DFID Nepal Rural Access Programme 3 (RAP3)
Monitoring, Evaluation and Learning (MEL) Component

**TECHNICAL ASSESSMENT OF COMPLETED RAP
ROADS
(INDEPENDENT VERIFICATION - 2018 ROUND 2)**

Date: December 2018

Submitted by Itad

Photo 3: Chainage 14+250 to 14+270: Composite wall and crash barriers with minimal bioengineering works on slope

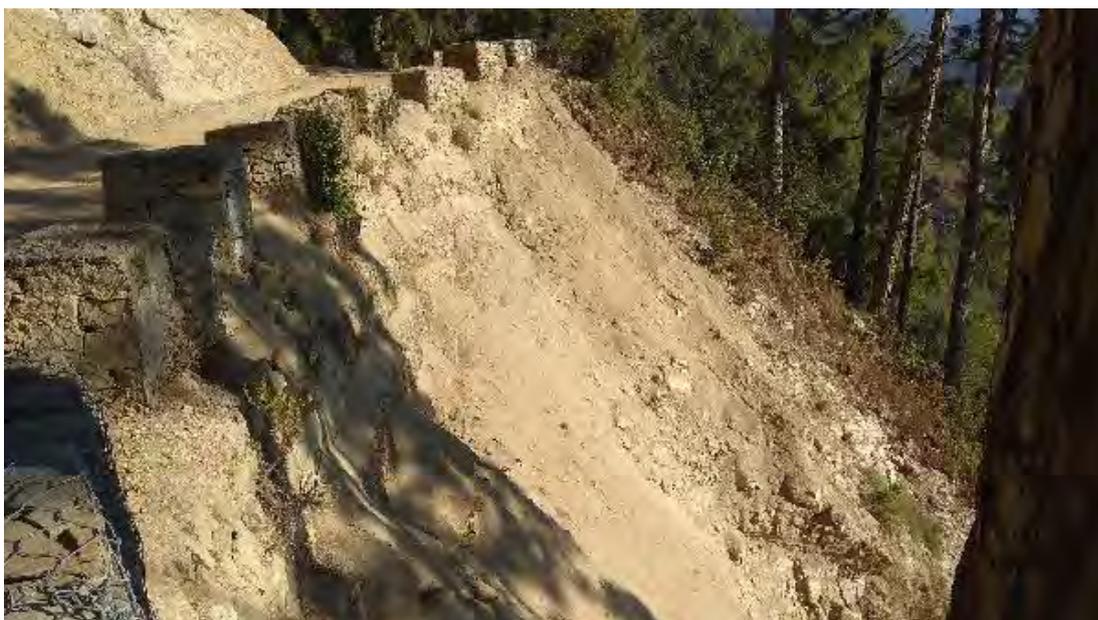
- The overall longitudinal gradient of the road is 0% to 7% which is within the Nepal Rural Roads Standard.
- The compaction of earthwork in filling areas is adequately completed and satisfactory. The construction quality of material is good. Constructed earthen rural road can be operated throughout the year.
- Bioengineering works is done in critical and applicable sections (like 0+600, 3+580-3+930, 4+650, 4+780, 4+860, 4+300, 4+880, 5+030, 5+570, 5+650, 6+050-6+110, 6+500, 8+550, 16+460-16+475) but in some of locations is not functioning like in chainage 14+250 to 14+270, 6+800 to 6+995.
